## ADDENDUM

**ADDENDUM NO.:** 01  
**PROJECT NAME:** CIP Central Hearing Facility Roof and MEP Upgrades  
**PROJECT NO.:** 04044  
**CONTRACT NO.:** C1606  
**DATE OF ISSUE:** December 21, 2023

### NOTICE OF CHANGES, MODIFICATIONS, OR CLARIFICATIONS TO CONTRACT DOCUMENTS

Sheet: **ACD-101E**

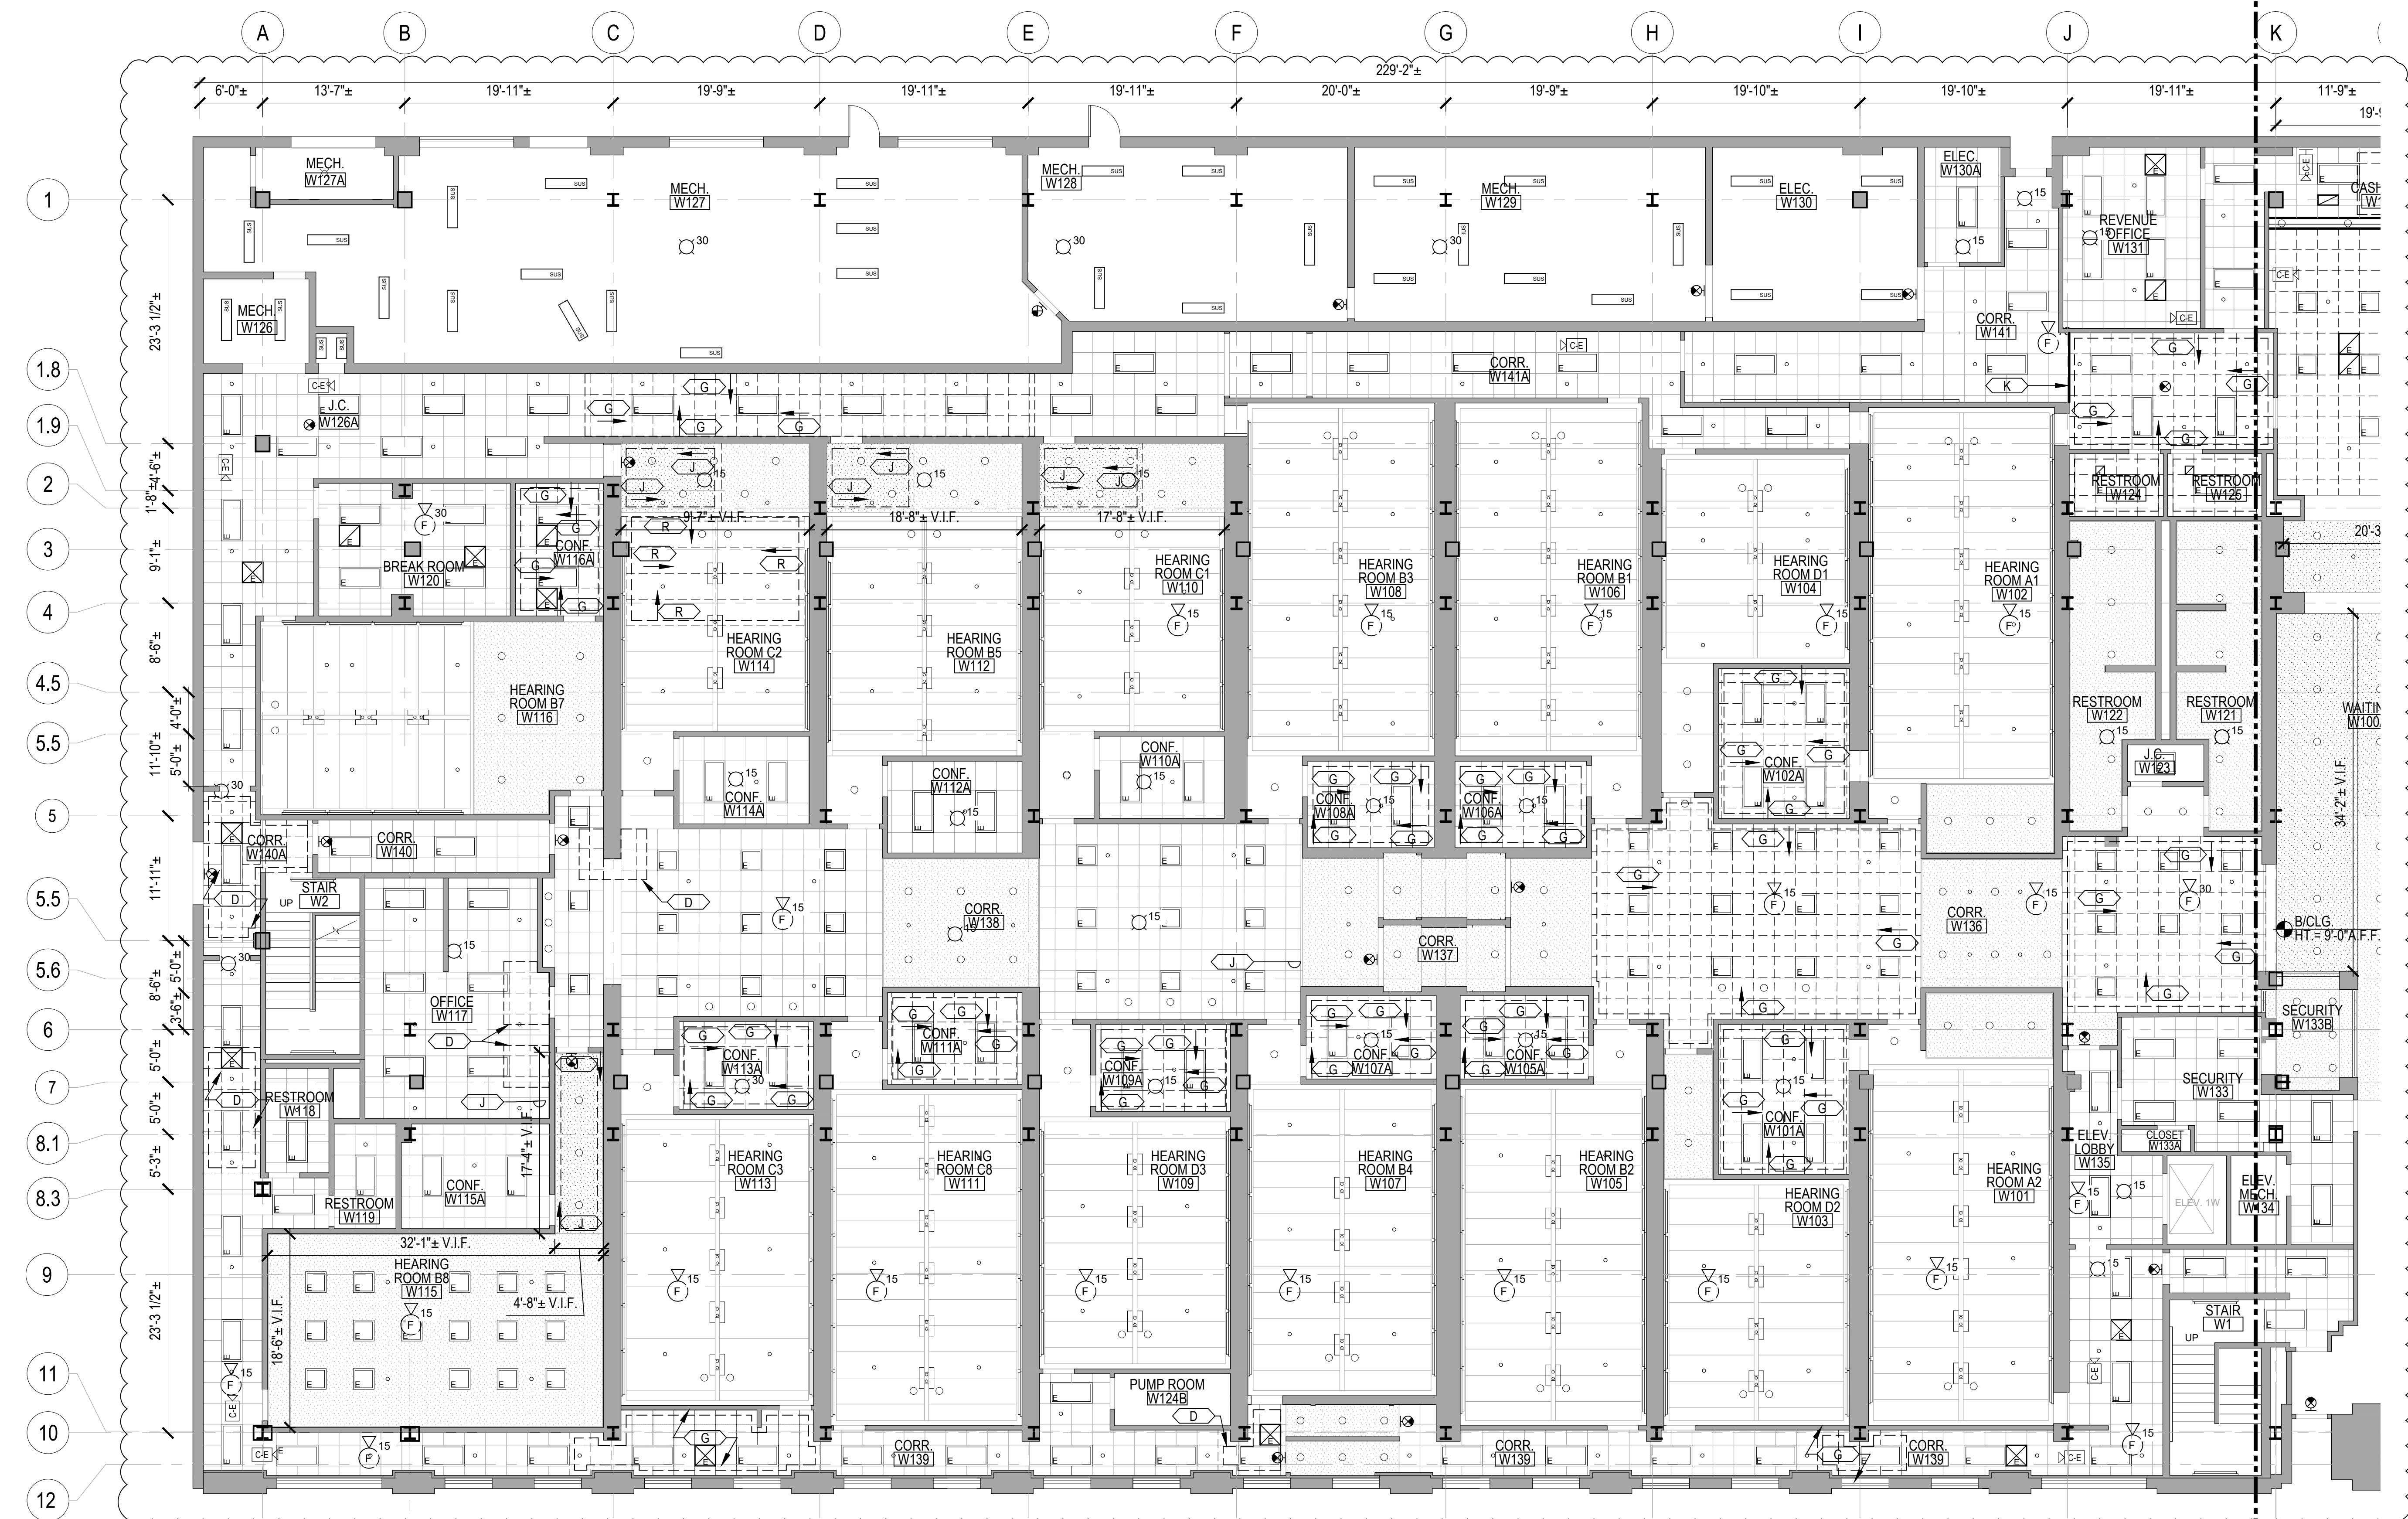
**Change 1** Drawing Index No. G-011– **REVISED** to reflect added drawings dated 12.21.23  
**Change 2** Drawing No. ACD-101E – **REVISED** sheet to add existing ceiling hung devices, dated 12.21.23

ADDED FIRE ALARM DEVICES AND EXIT SIGNS

**Response:** [Ceiling plans have been revised to identify the ceiling-mounted exit signs and fire alarm devices. Please refer to architectural drawings included in this addendum.](#)

Sheet: **ACD-101W**

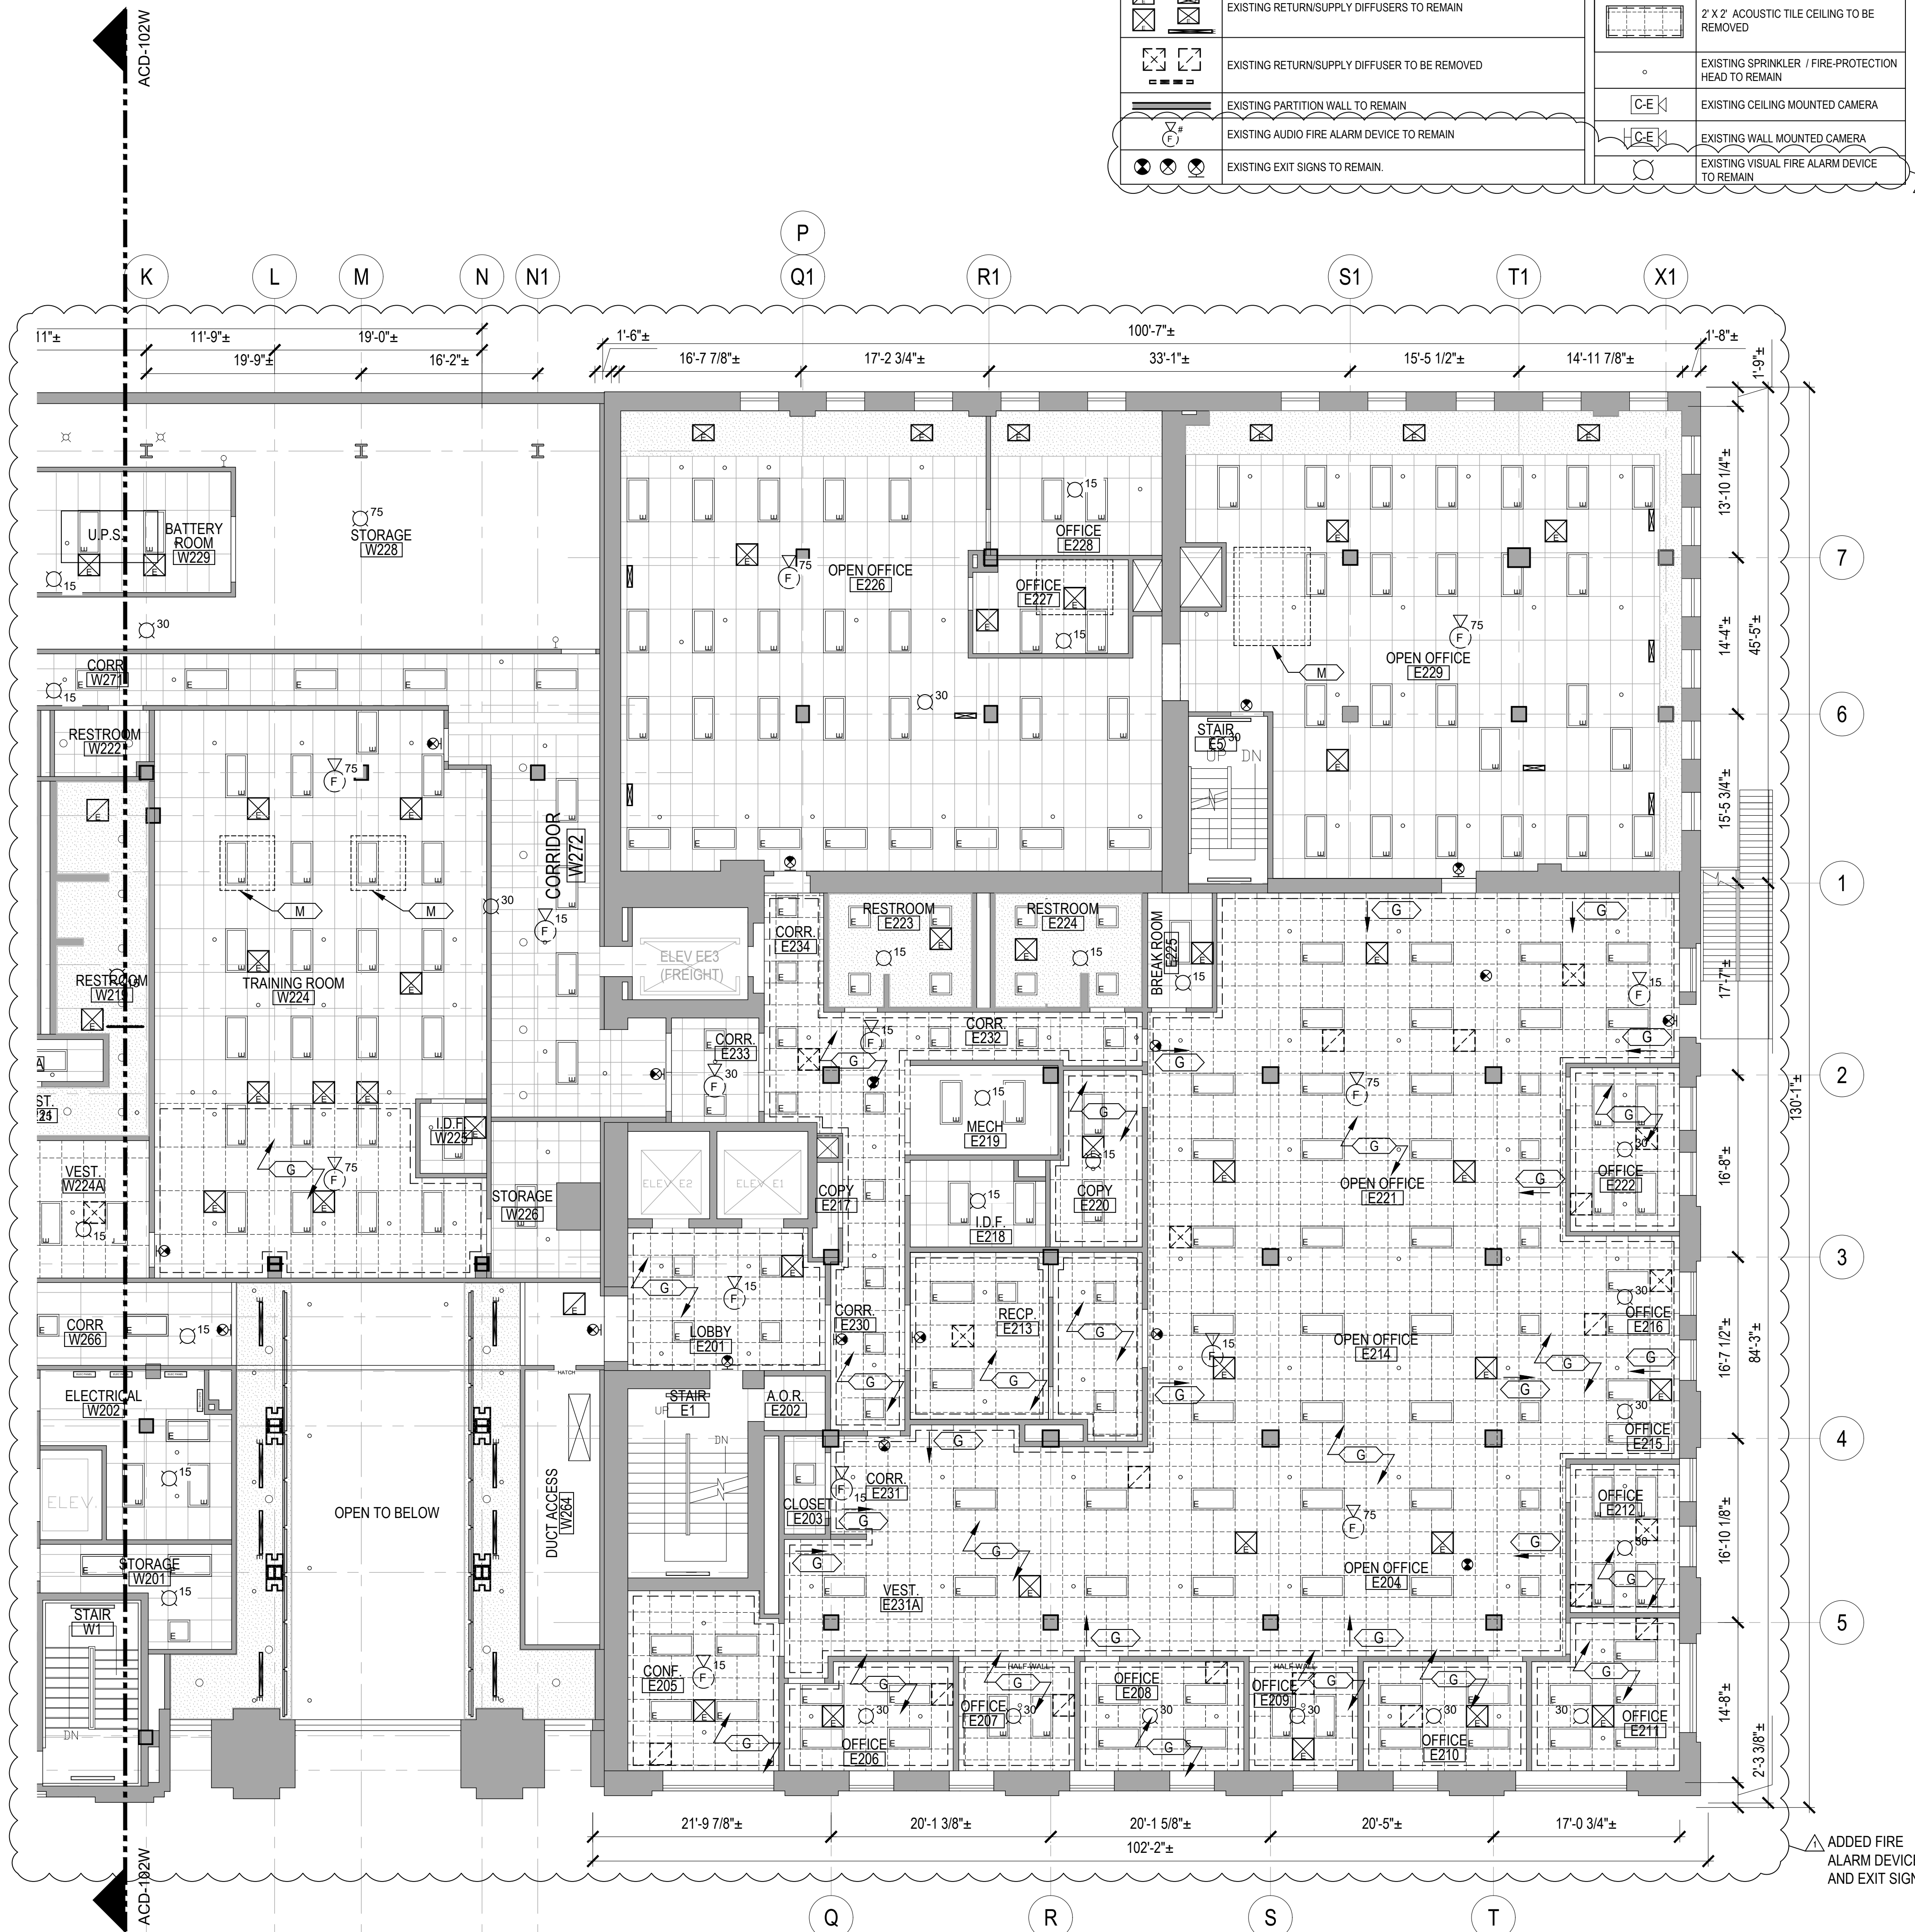
**Change 3** Drawing No. ACD-101W – **REVISED** sheet to add existing ceiling hung devices, dated 12.21.23  
**Change 4** Drawing No. ACD-102E – **REVISED** sheet to add existing ceiling hung devices, dated 12.21.23

**1 SECOND FLOOR EAST REFLECTED CEILING DEMOLITION PLAN**  
SCALE: 1/8"=1'-0"

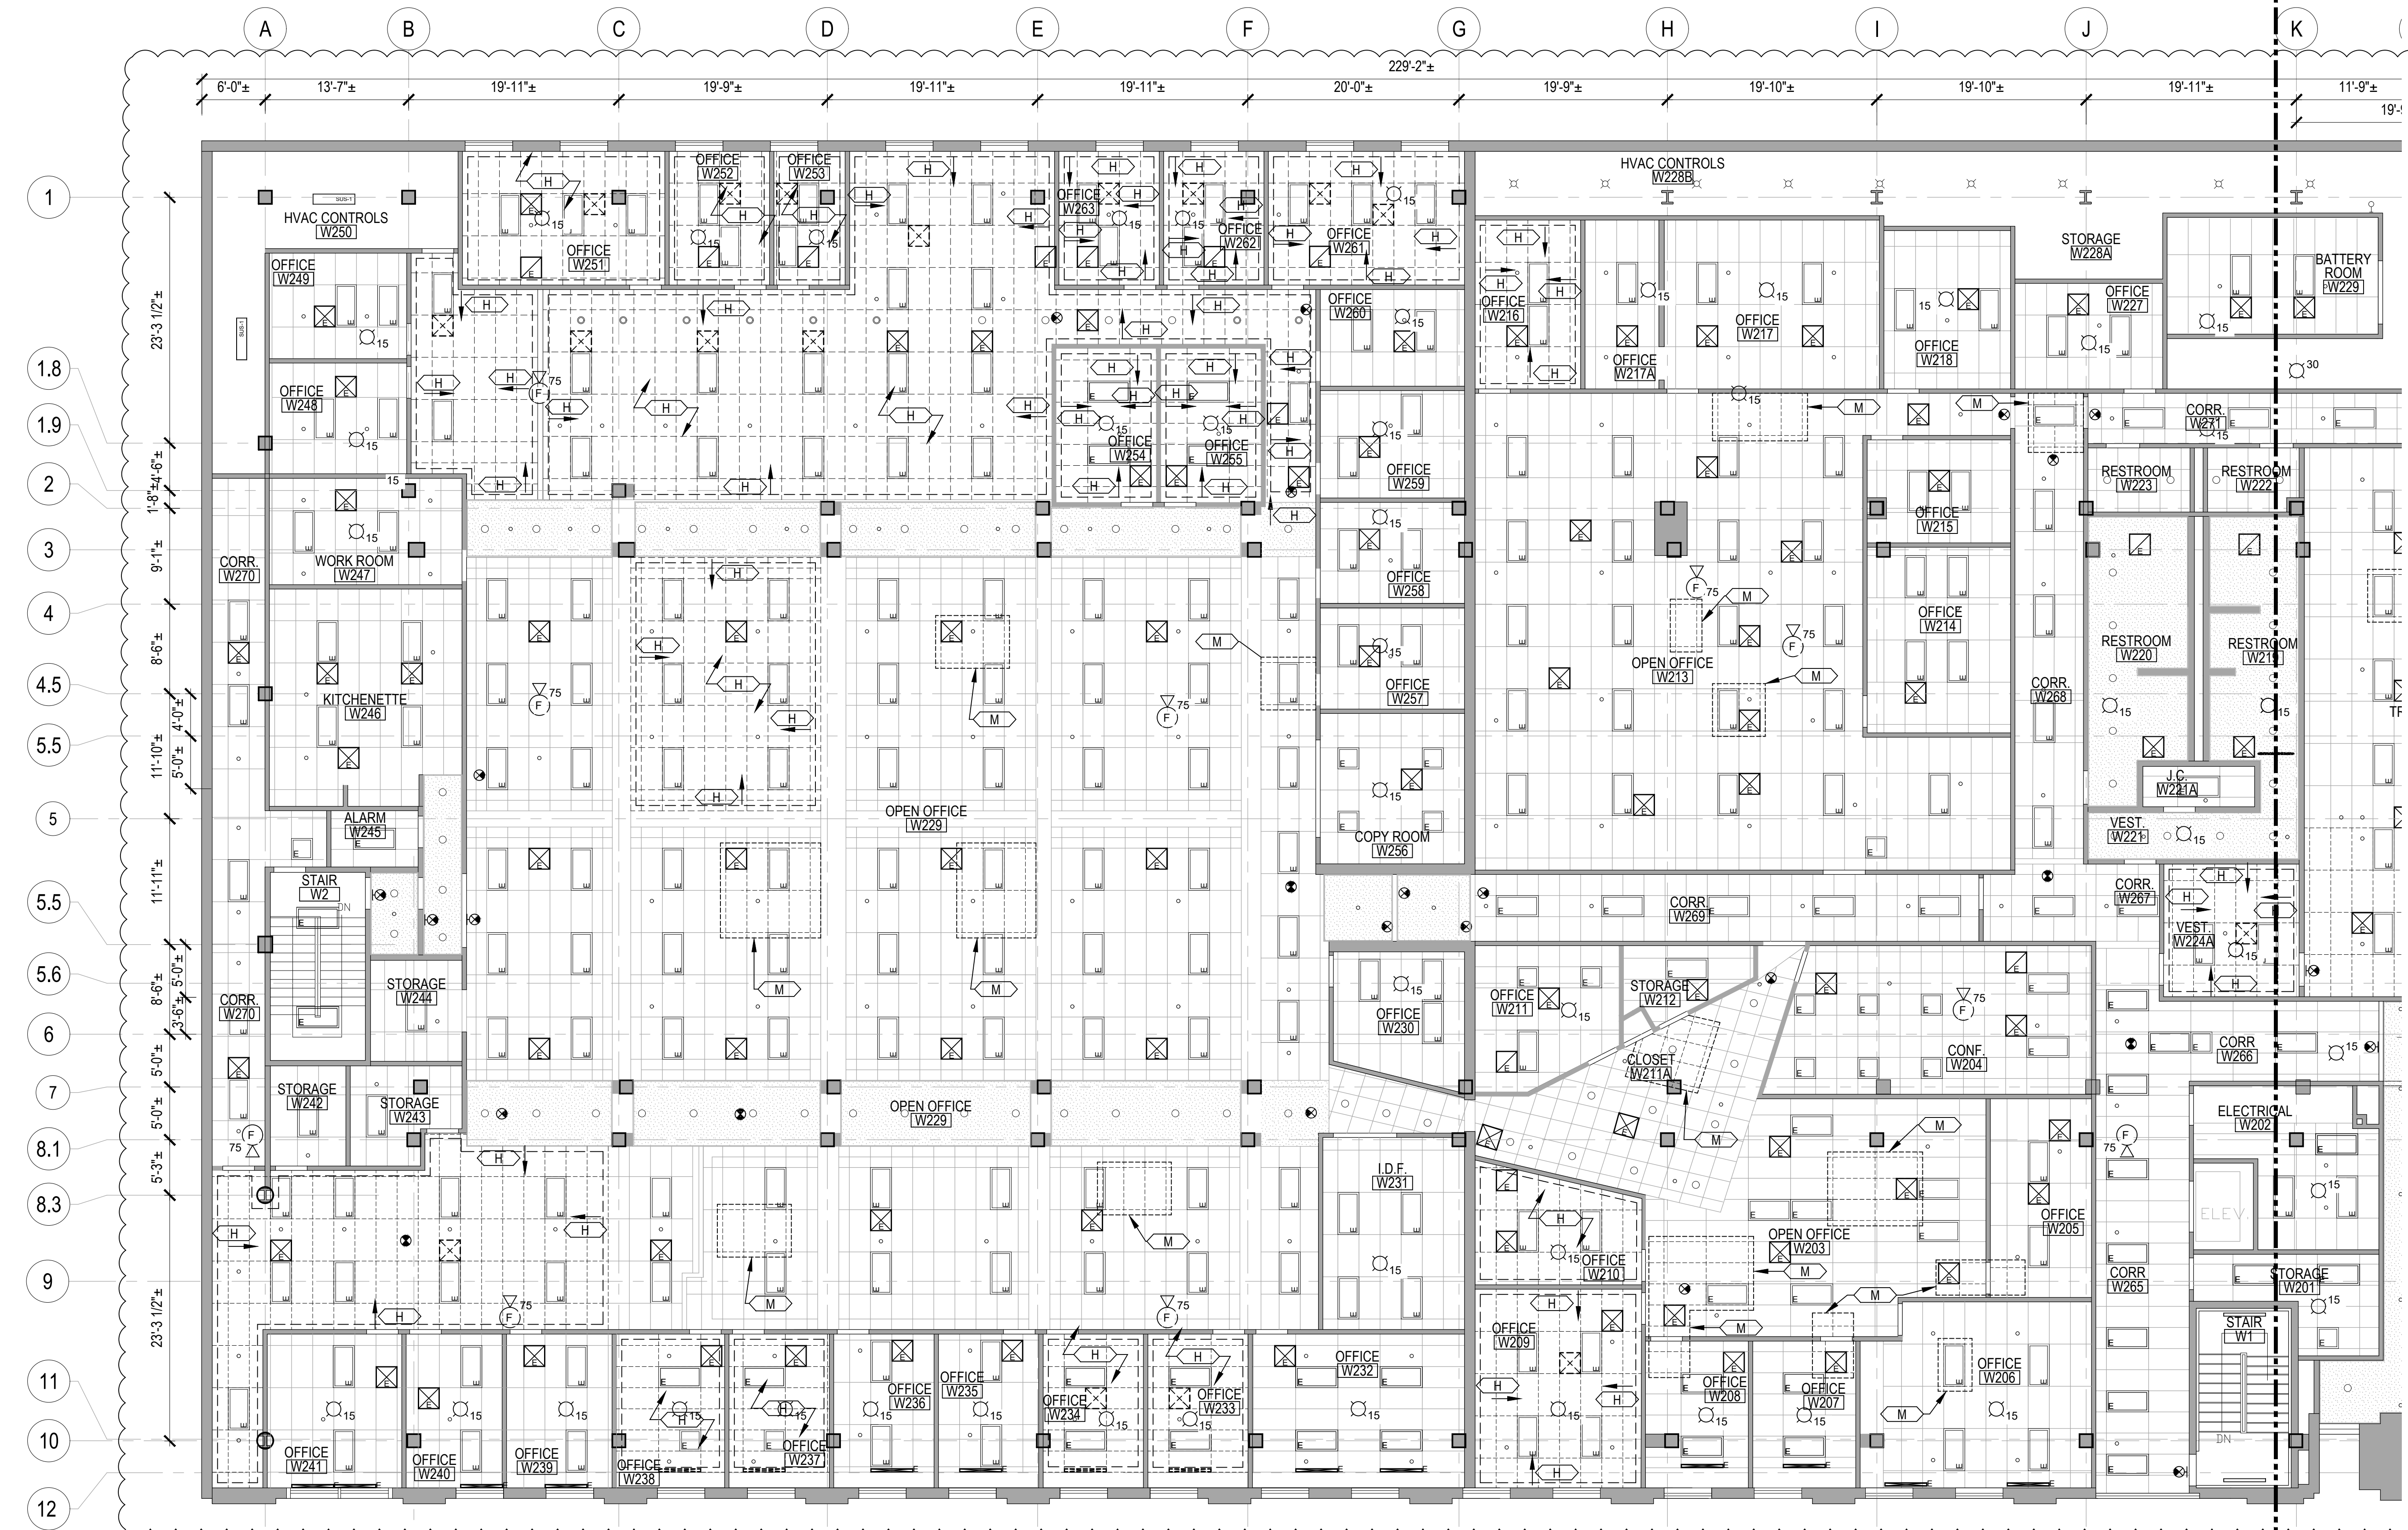
▲ ADDED FIRE ALARM DEVICES AND EXIT SIGNS
